# UNITED STATES PATENT AND TRADEMARK OFFICE

| APPLICATION NO.  | FILING DATE | FIRST NAMED INVENTOR   | ATTORNEY DOCKET NO. | CONFIRMATION NO. |
|--|-------------|------------------------|---------------------|------------------|
| 10/561,637   | 12/19/2005  | Yoshimichi Kawai       | 52433/831           | 2907             |

# Office Action Summary

**DETAILED ACTION**

**Figure 6 from Odell**

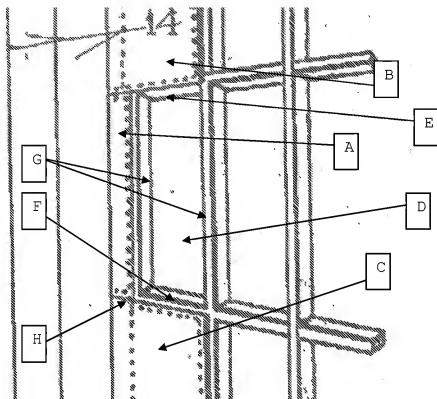
Claim 1: Odell discloses a construction of an opening (see Fig. 6: below) comprising a side face wall frame member ("A" below), a vertical panel ("B" below) and a wainscot panel ("C" below), the side face wall frame members comprise an opening ("D" below) formed by an opening upper frame member ("E") to which a lower end of the vertical panel is fixed (as shown), an opening lower frame member ("F") to which an upper end of the wainscot panel is fixed (as shown), a longitudinal frame member ("G") raised on both on both sides of the frame members, and transverse frame members (not shown, but proximate "H" below), the vertical panel (se 35 USC §112 rejection above) is integrated with upper parts of the side face wall and the

wainscot panel are integrated with lower parts of the side face wall (as shown). Odell does not disclose the limitation of having two side face wall members (i.e., a member equivalent to "A" on the other side of the opening,) which would result in the side face members being divided. It would have been obvious at the time the invention was made to a person having ordinary skill in the art as a matter of duplication of parts to have this limitation because duplication of parts has no patentable significance unless a new and unexpected result is produced. *In re Harza*, 274 F.2d 669 (CCPA 1960). See MPEP §2144.04. Odell further does not disclose the additional longitudinal members as claimed, though Bailey discloses longitudinal members (1) in pairs around a window opening. It would have been obvious at the time the invention was made to a person having ordinary skill in the art to have additional members as claimed for further strengthening the opening as needed. Odell further does not disclose that the members are made of steel, though Howell discloses a steel framing system (Col. 1, generally). It would have been obvious at the time the invention was made to a person having ordinary skill in the art to use the steel system in Howell as for the framing system in Odell because it is well known in the art to use steel framing due to its strength and durability and longer life over its wood counterpart.
